Subject: Response to Portion of NRC RAI Letter No. 368 Related to ESBWR Design Certification Application - DCD Tier 2 Section 3.8 - Seismic Category I Structures; RAI Number 3.8-96 S05

**Partial Response to NRC RAI Letter No. 386
Related to ESBWR Design Certification Application¹**

DCD Tier 2 Section 3.8 – Seismic Category I Structures

RAI Number 3.8-96 S05, Revision 1

Figure 3.8-96(2) Shear Key Configuration for the RB/FB Structure

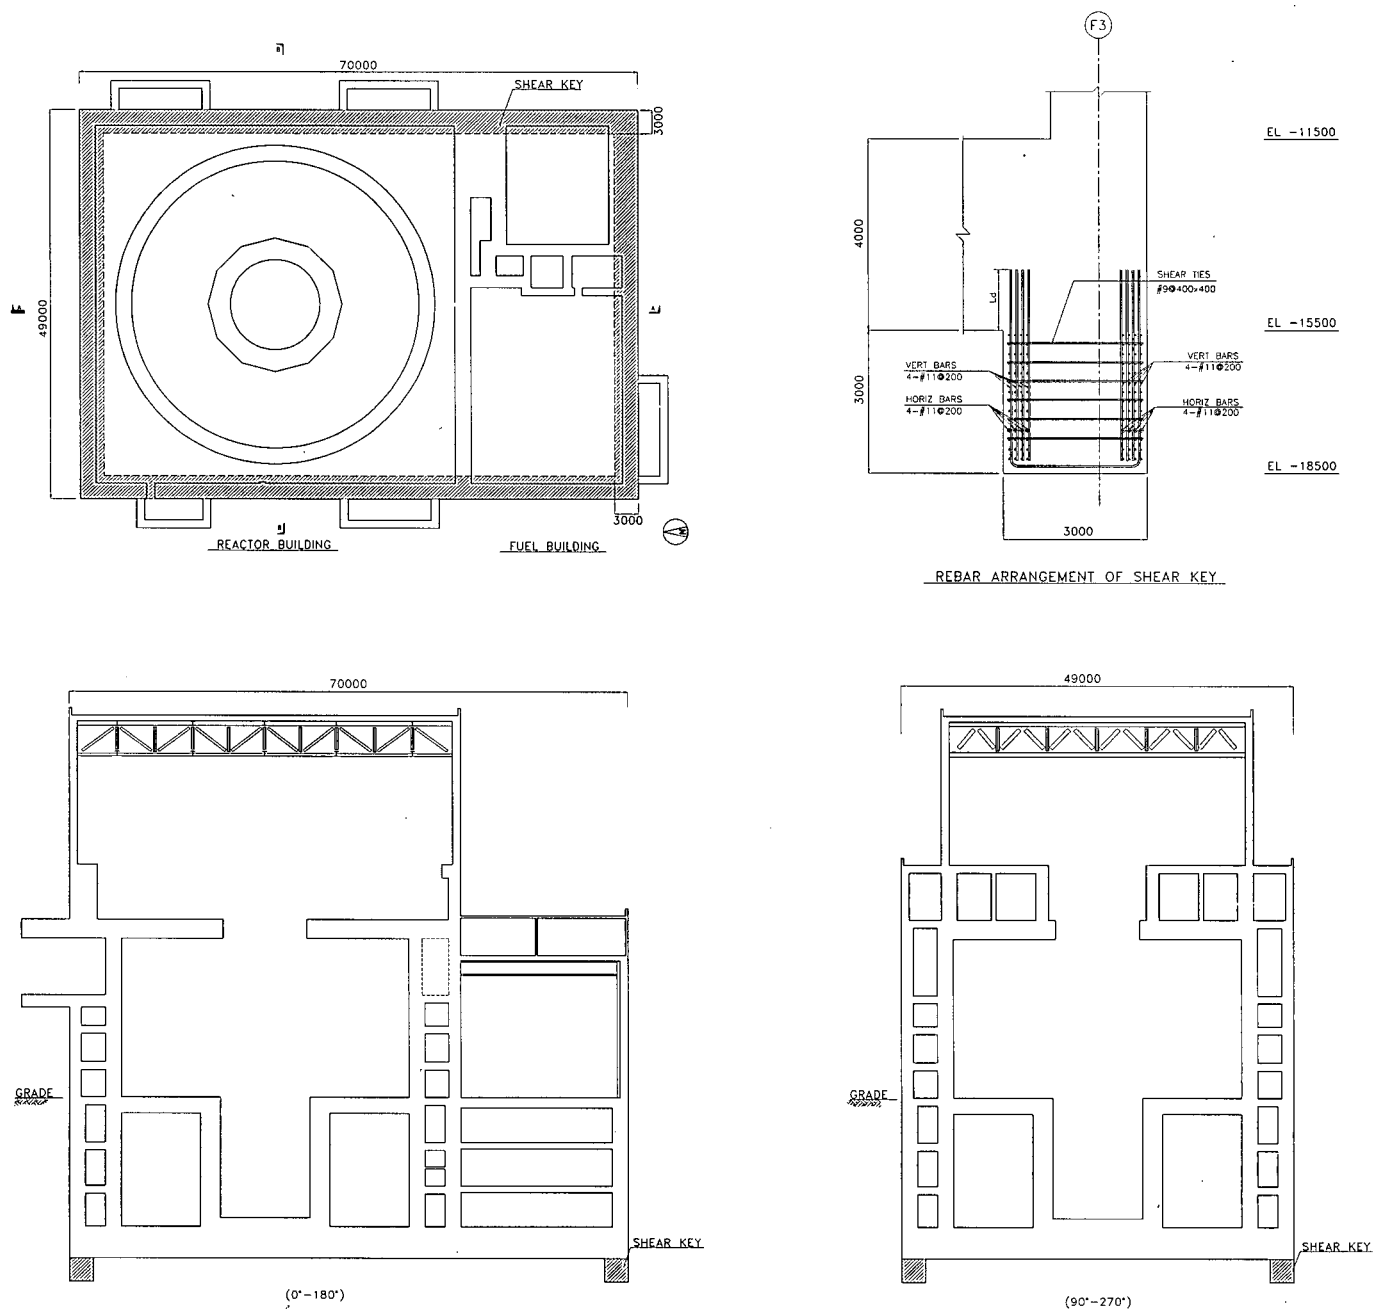
- C) *In Item (9) (pages 22 through 26 of 27), a description of the revised sliding evaluation is presented. This new calculation considers the static coefficient of friction beneath the basemat and on the side walls, passive soil pressures, and at rest soil pressures. As indicated in the prior revision to this RAI, the use of these terms should be based on a consistent set of expected deformations. For example, to develop the full passive pressure capability of the soil implies that sufficient*

The shear key configuration is shown in Figure 3.8-96(2). The reinforcement in the shear key is determined to resist full capacity of the passive pressure less the active pressure.

Figure 3.8-96(4) Coefficient as a Function of Poisson's Ratio

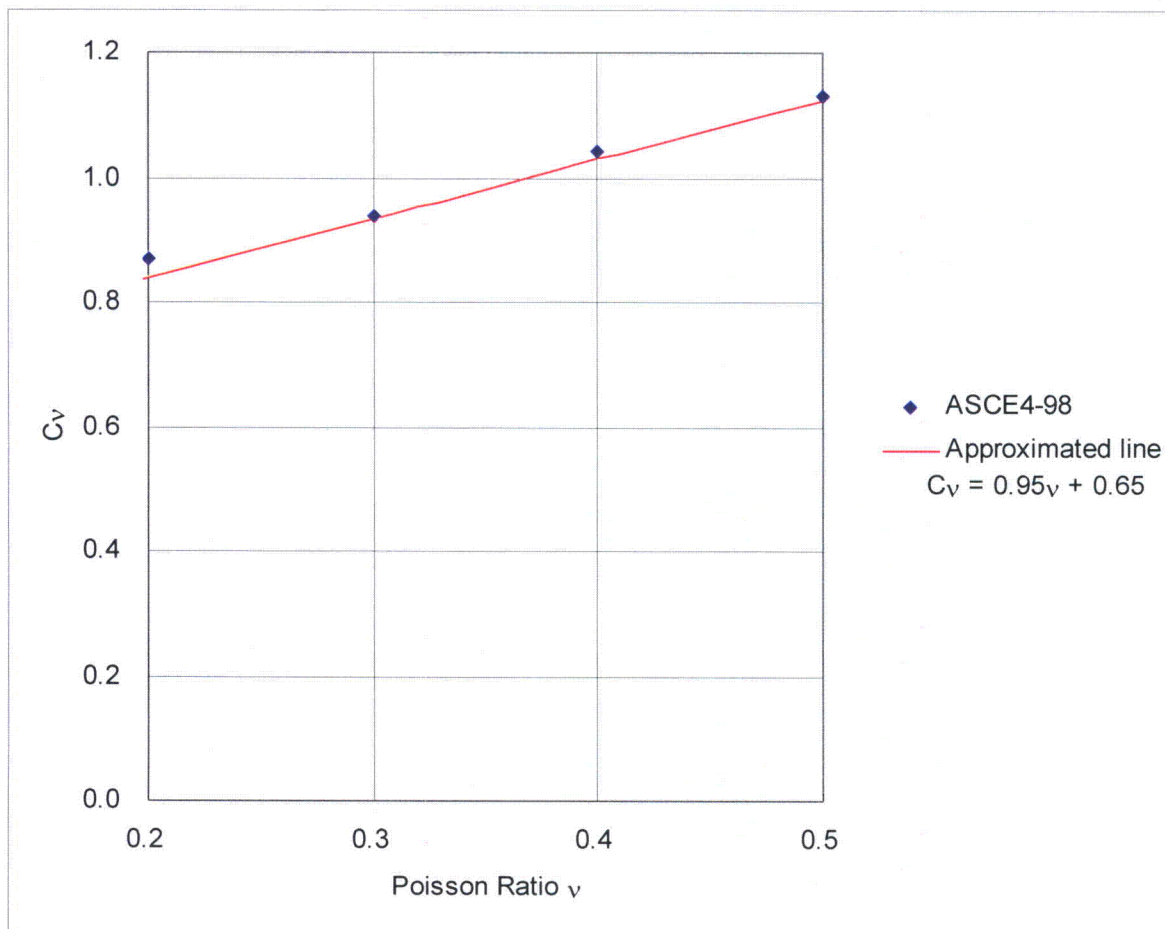
In the same section, GEH also provides the following recommendation: "To ensure the wall design seismic lateral pressures induced from backfill are not exceeded, a COL item will be added in DCD Tier 2 Table 2.0-1 to limit the product of peak ground acceleration (α) of the site-specific Foundation Input Response Spectra (FIRS) in g's, Poisson's ratio (ν) and density (γ) as follows: $\alpha (0.95\nu + 0.65) \gamma$: 1220 kg/m³ (76 lbf/ft³) maximum." Provide an explanation and the basis for this recommendation.

The seismic lateral pressure limit, $\alpha (0.95v + 0.65) \gamma$, is derived from the resultant force F_r equation in ASCE 4-98, Figure 3.5-2, as follows:

- α : horizontal earthquake acceleration (g)
- γ : soil unit weight
- H : embedment height
- C_v : coefficient as a function of Poisson's ratio, v . A numerical analysis of this equation shows that C_v , the coefficient as a function of Poisson's ratio, can be approximated by a straight line, $0.95v + 0.65$, as shown in Figure 3.8-96(4).

Figure 3.8-96(5) Forces for RB/FB Sliding Evaluation

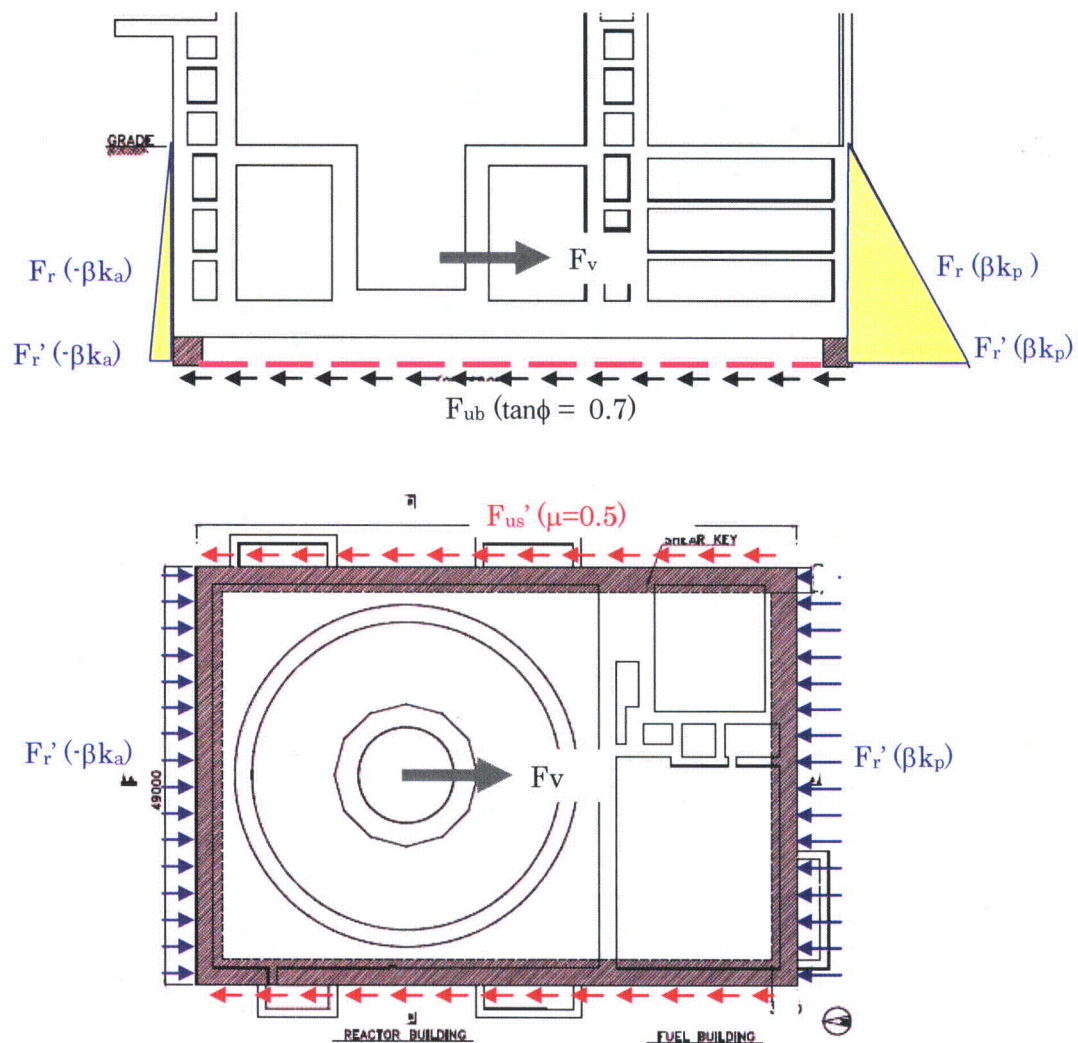
(b) With the troughs added to the bottom of the mud mat and the use of shear keys beneath the basemat, the governing sliding interface may now be a horizontal plane in the soil at the elevation corresponding to the bottom of the shear keys. At this elevation there would no longer be any lateral resistance contribution from the surcharge of the building acting on the shear keys when calculating F_{us}' and F_r' . Explain whether another calculation was performed to determine the sliding factor of safety at the elevation of the bottom of the shear keys and describe the results of that evaluation.

- (b) The sliding calculation is redefined to include passive pressure on the embedded exterior walls and the shear keys to determine the sliding factor of safety at the elevation of the bottom of the shear keys for the RB/FB. The lateral resistance contribution from the surcharge of the building acting on the shear keys is eliminated from the Equations 4 and 5 for F_{us}' and F_r' in GEH's response to NRC RAI 3.8-96 S04 (MFN 09-449, dated 7/1/09).

The various driving and resisting forces are illustrated in Figure 3.8-96(5). The revised sliding evaluation is shown at the end of this supplemental response.

The FS is evaluated by taking the minimum values of the $FS(t)$ time history calculated per the following equation. See Figure 3.8-96(5) for each force.

Figure 3.8-96(7) Forces for CB Sliding Evaluation

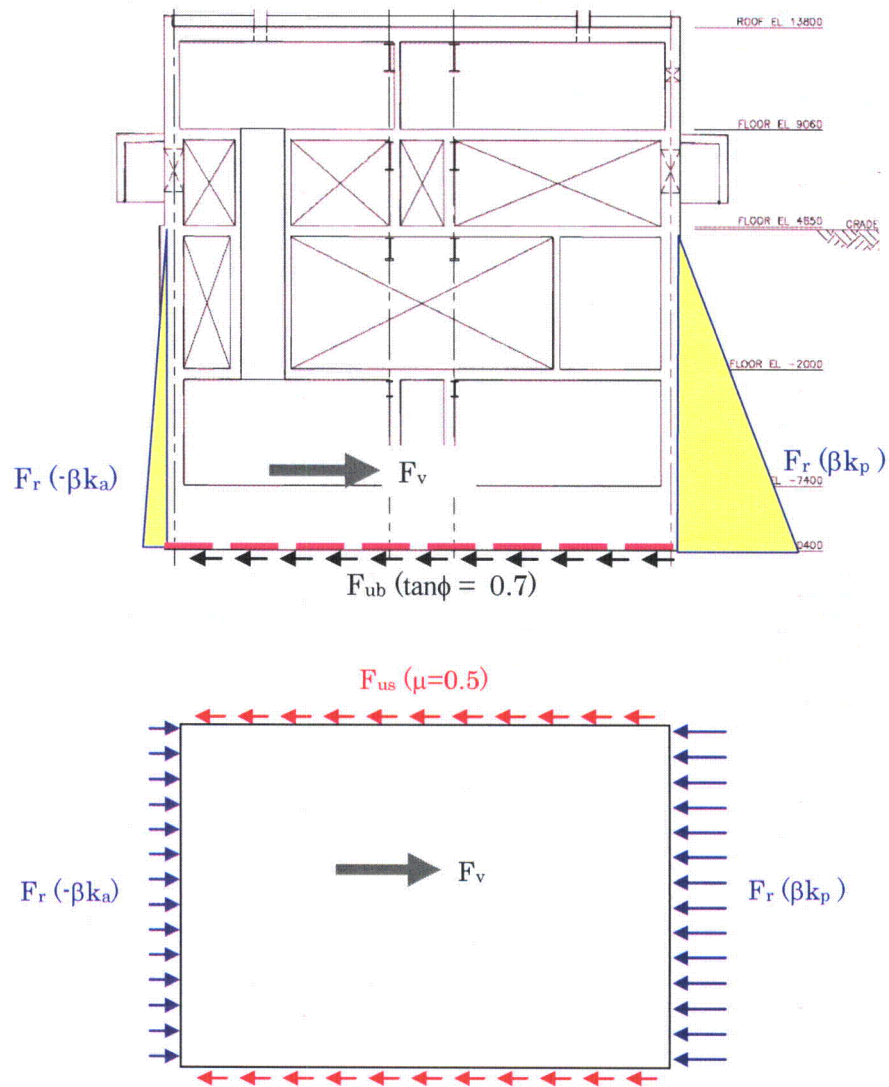
Item D response refers to a sliding evaluation approach presented at the end of the supplemental response. For all three structures (RB/FB, CB, and FWSC), GEH is requested to address the following items for this sliding evaluation:

The FS is evaluated by taking the minimum values of the $FS(t)$ time history calculated per the following equation. See Figure 3.8-96(7) for each force.
